SOL-ARK UNDERCHARGING BATTERIES

CSB Number	855-0017 REV B
Date	Dec 4, 2024

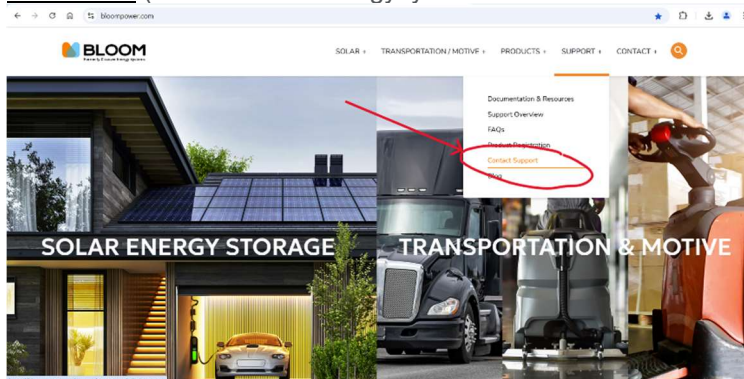
Discover lithium batteries are being undercharged when they are in closed-loop communication with Sol-Ark inverters, and the inverter is in grid-interactive mode. Undercharging occurs because the charge voltage being delivered to the battery is below the required voltage to charge. The condition can be observed by using LYNK ACCESS software to view the actual charge voltage delivered and comparing with the charge voltage displayed by the Sol-Ark Inverter. If a large delta between the target voltage and the actual voltage is observed corrective action is required.

Update to LYNK Firmware v2.1 or later. If this is not an option or desired, use LYNK ACCESS software for earlier versions to temporarily increase the voltage offset of the Max deltaV parameter to 7000 mV. This will raise the charge voltage delivered to the batteries.
